Memo

Re: Instructions for Wednesday, July 29, 2020 Planning Commission Meeting

Background Information & Staff Recommendations
City of Springboro Planning Commission Meeting—Conducted by Conference Call (Zoom)
Wednesday, July 29, 2020, 6:00 p.m.

Advance Drive PUD, Planned Unit Development, new commercial building

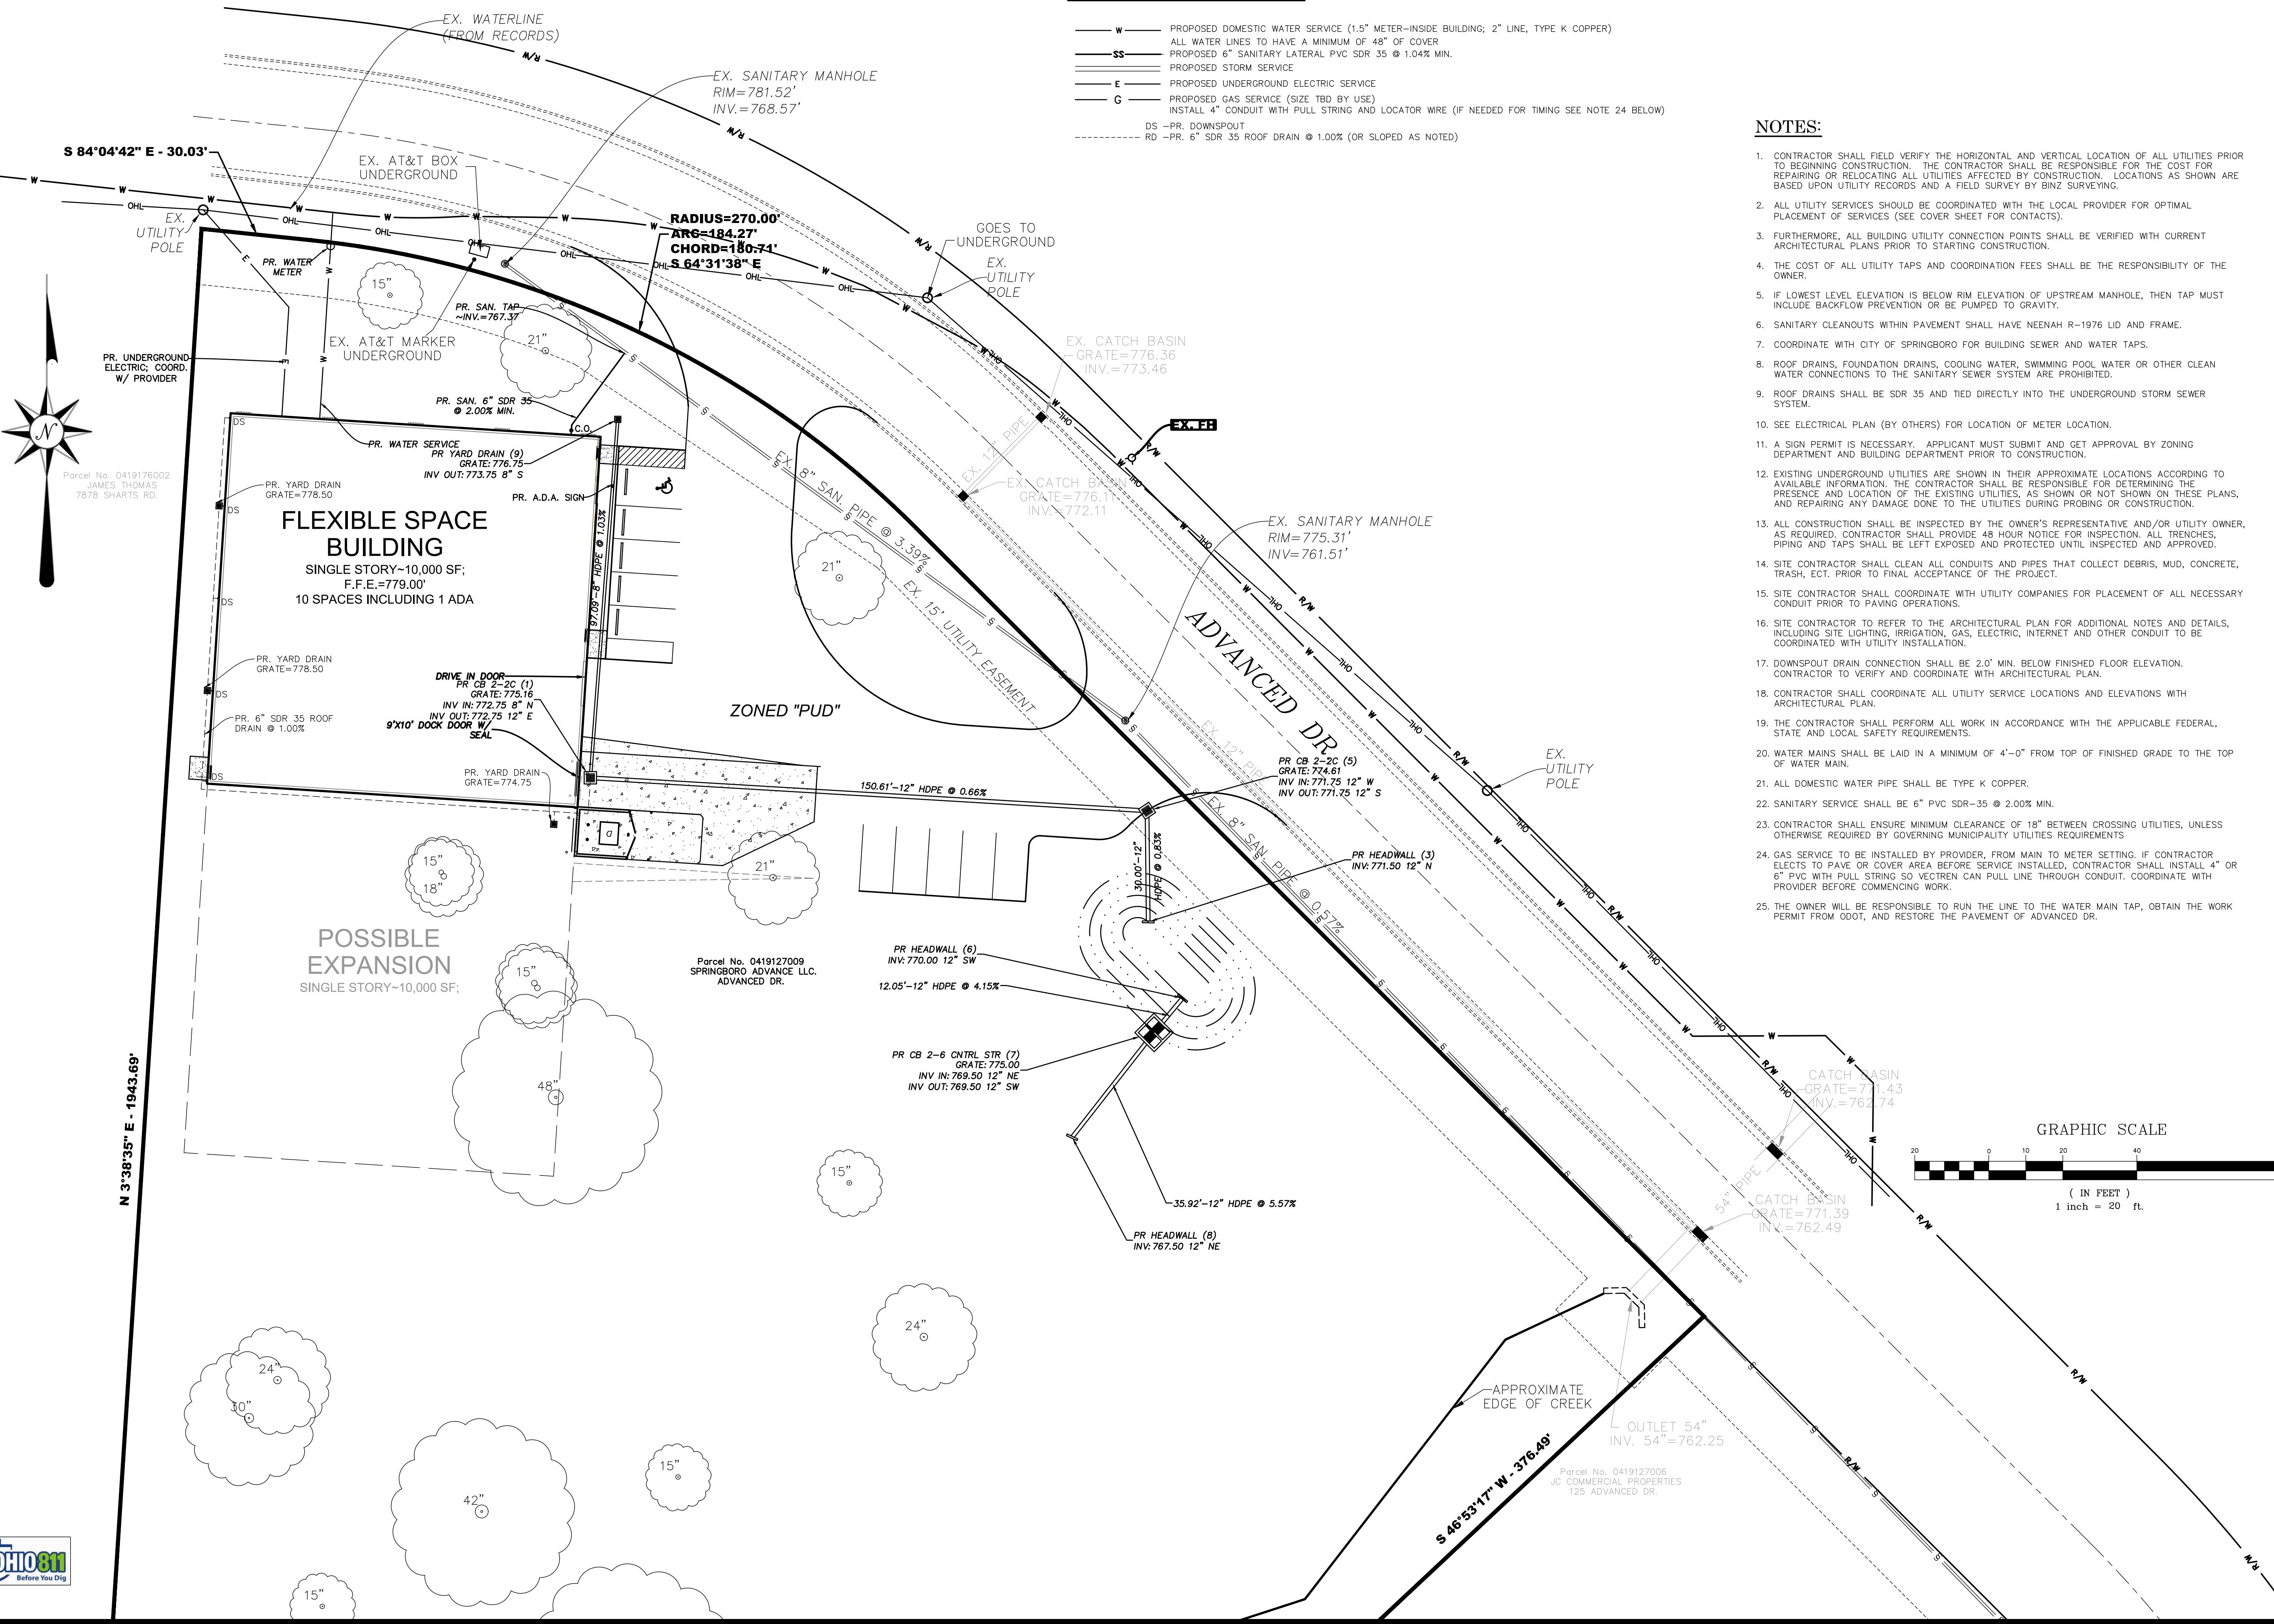
- 5. Water main to have 54" cover, and sanitary lateral to have minimum 2% slope. Adjust sheet notes on C-3.1 accordingly.
- 6. Revise Sheet C-3.1 to state water meter to be located inside of building.

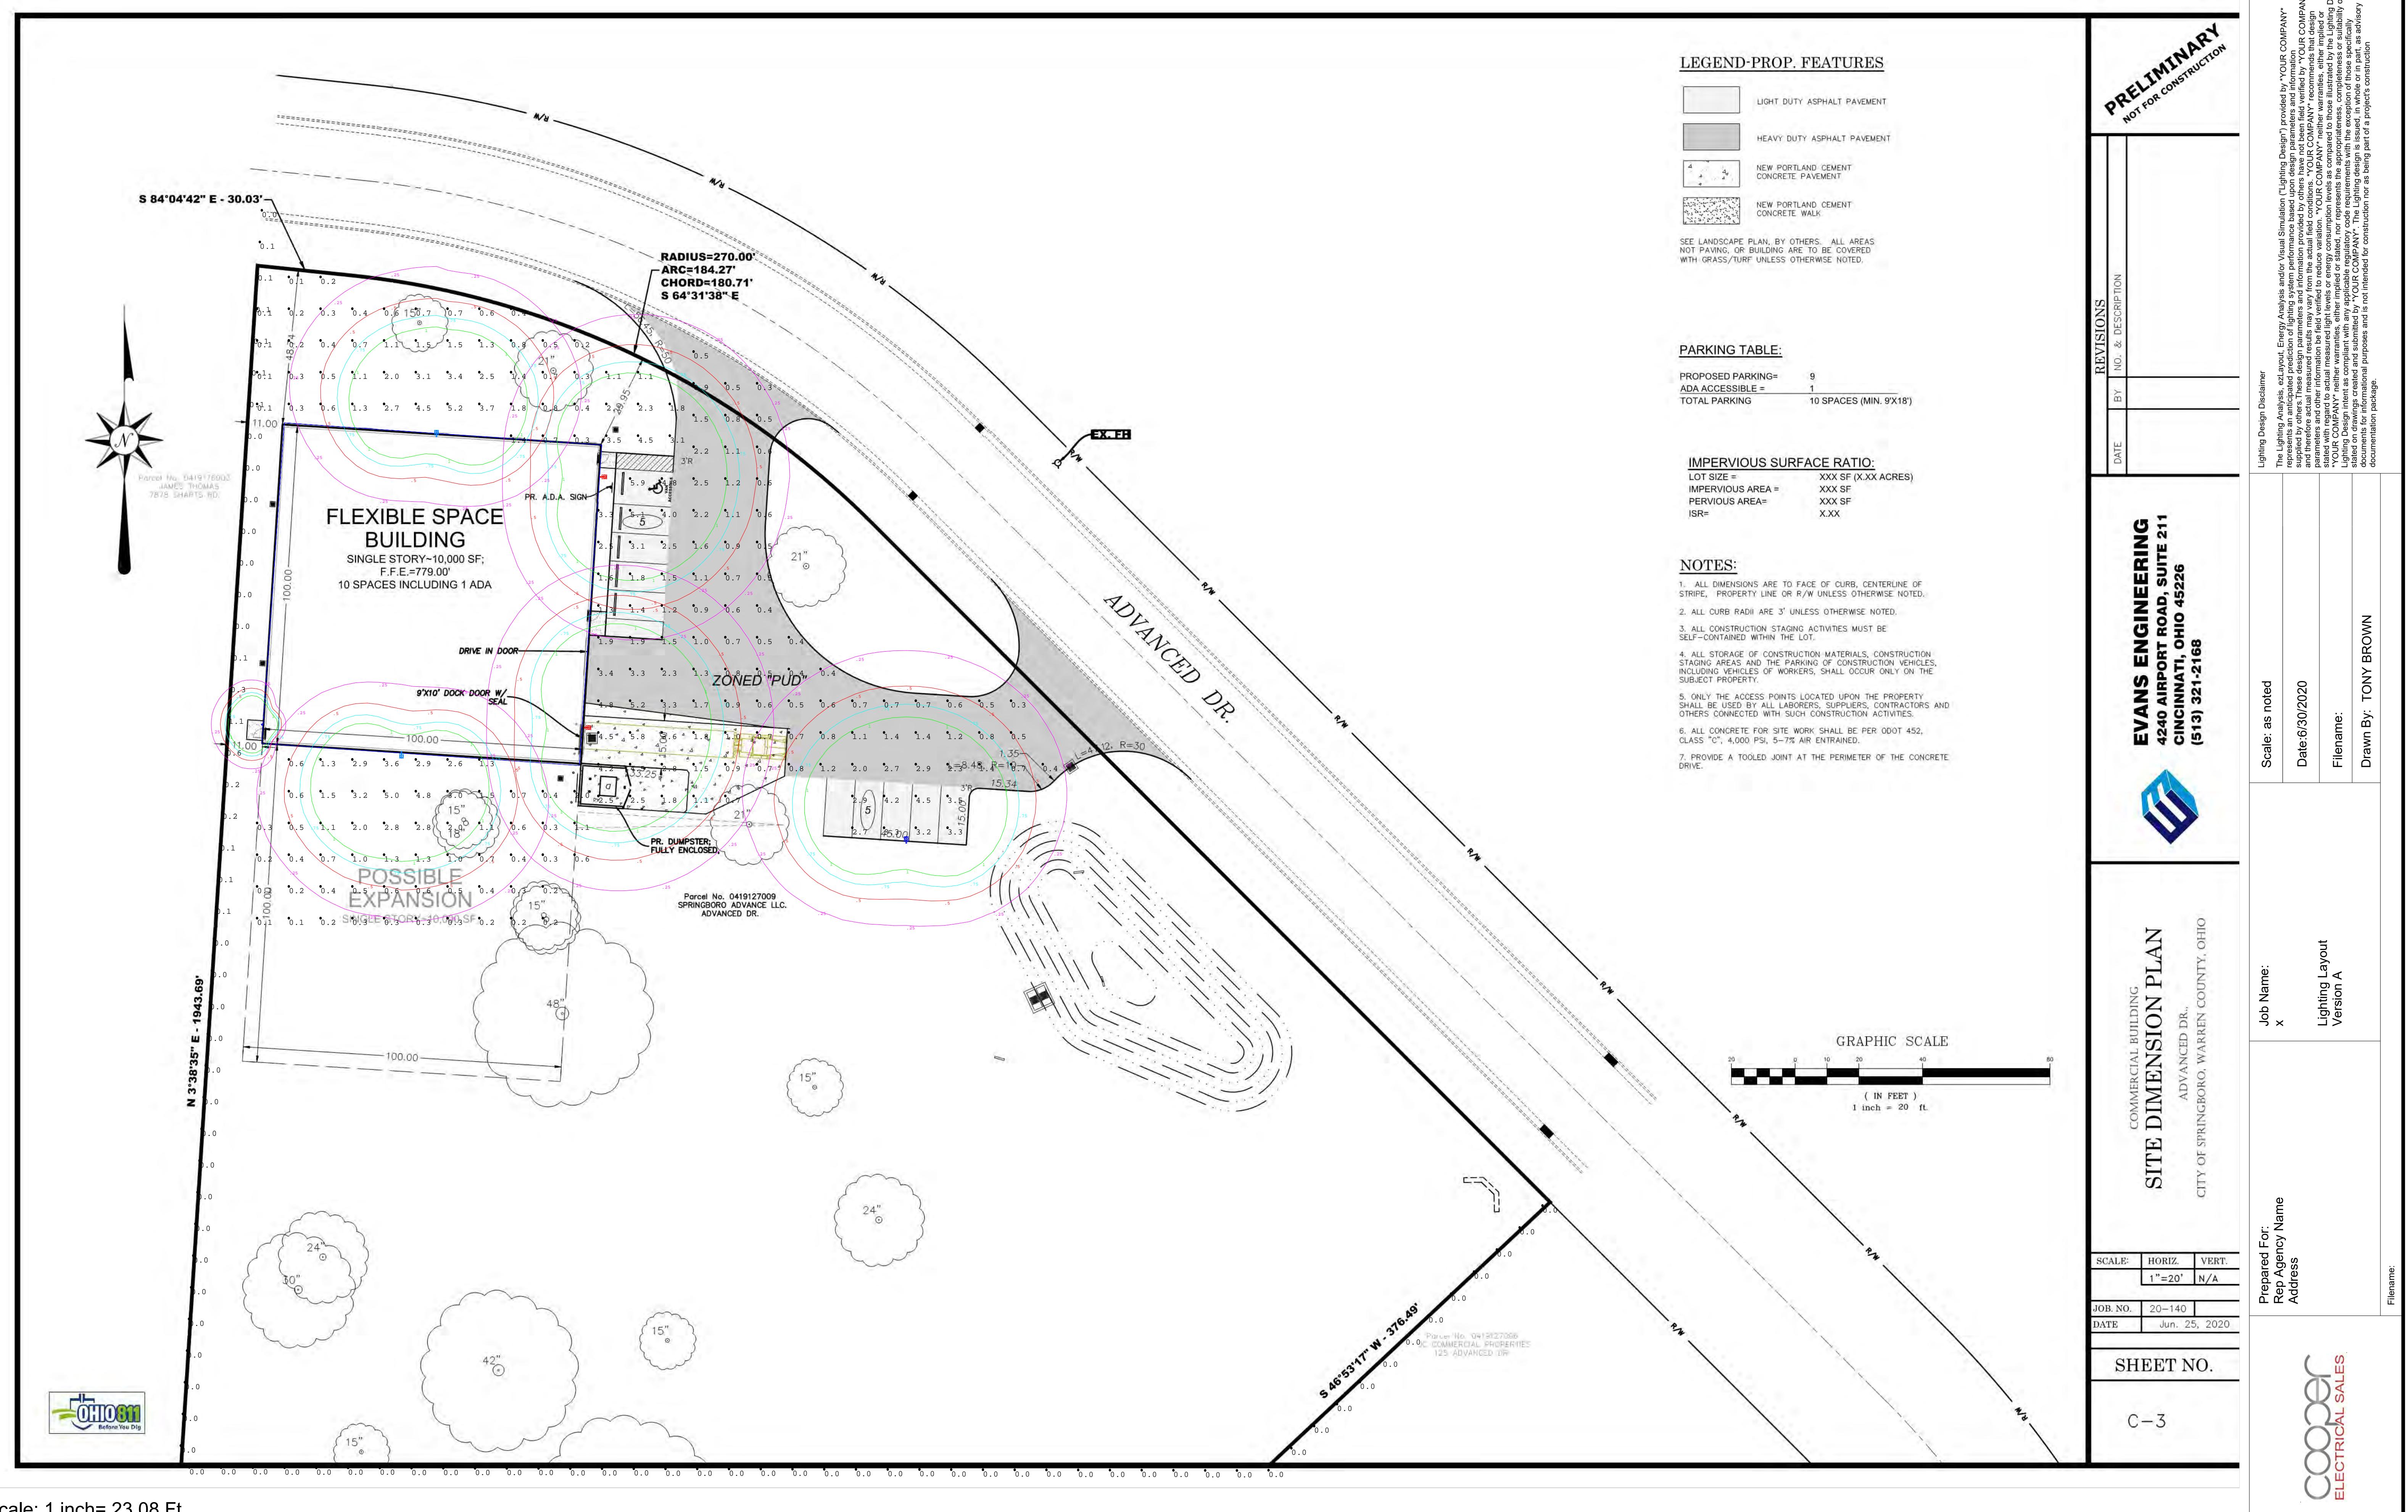
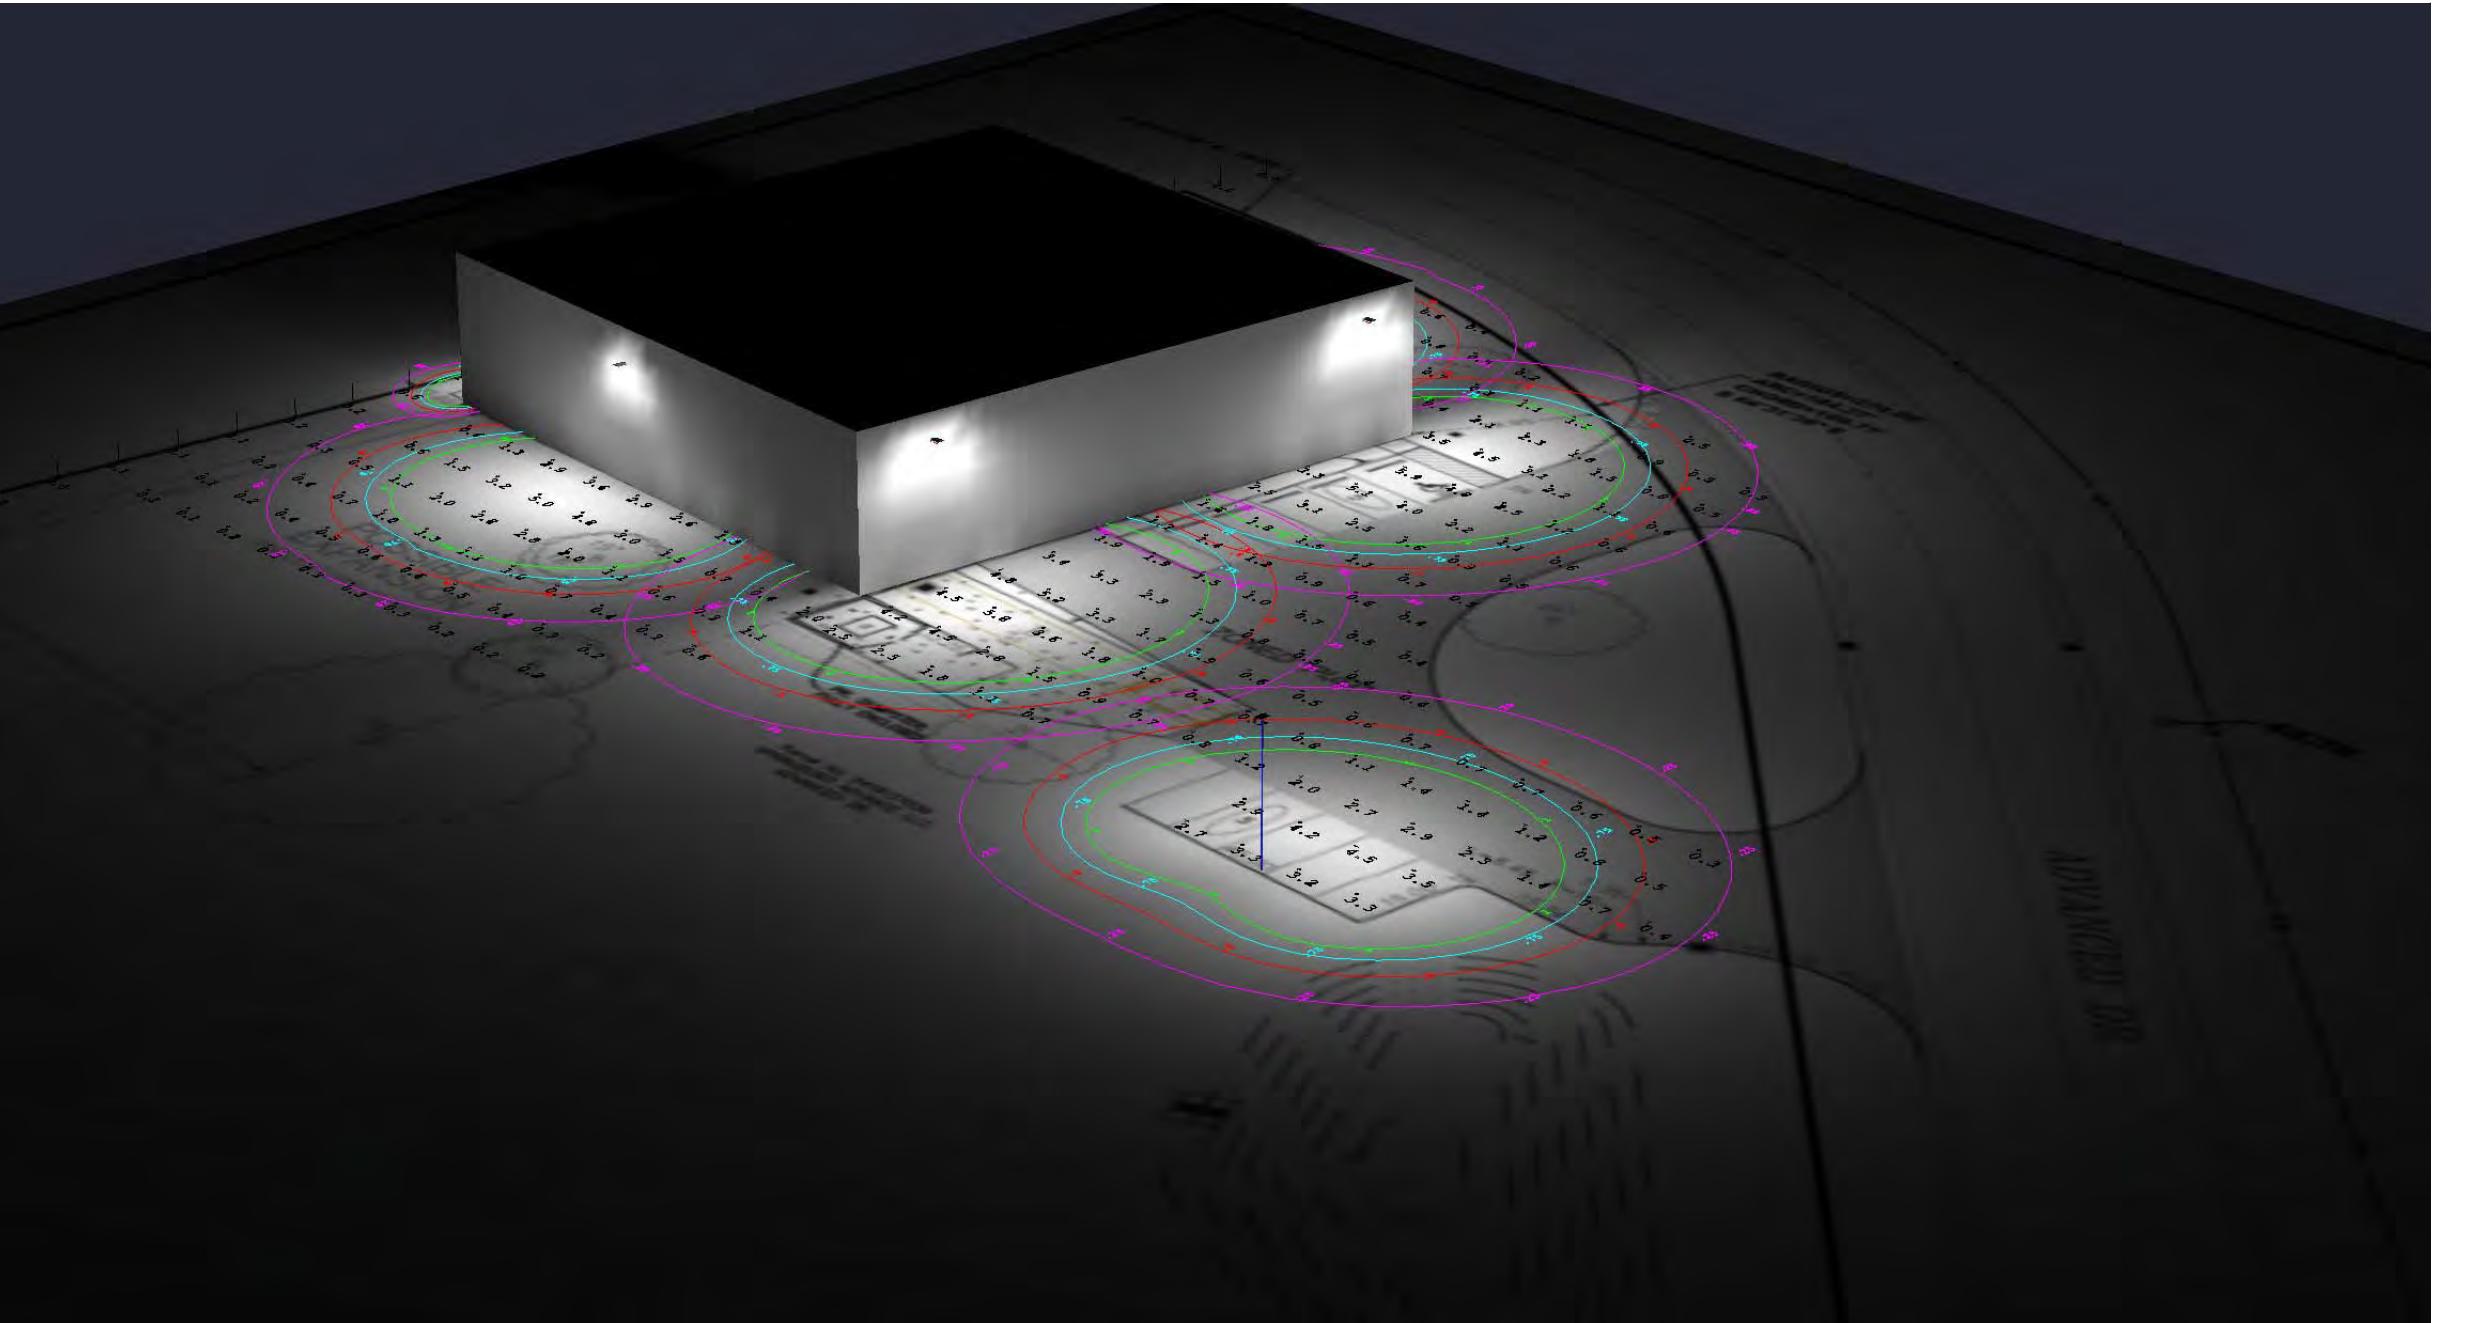
1. Regarding the proposed lighting plan, staff has the following comments:

- a. Proposed wall pack lighting is not acceptable. Coordinate with City staff on an acceptable fixture.
- b. Verify if lighting fixtures proposed comply with maximum 3500° Kelvin color-temperature standard.
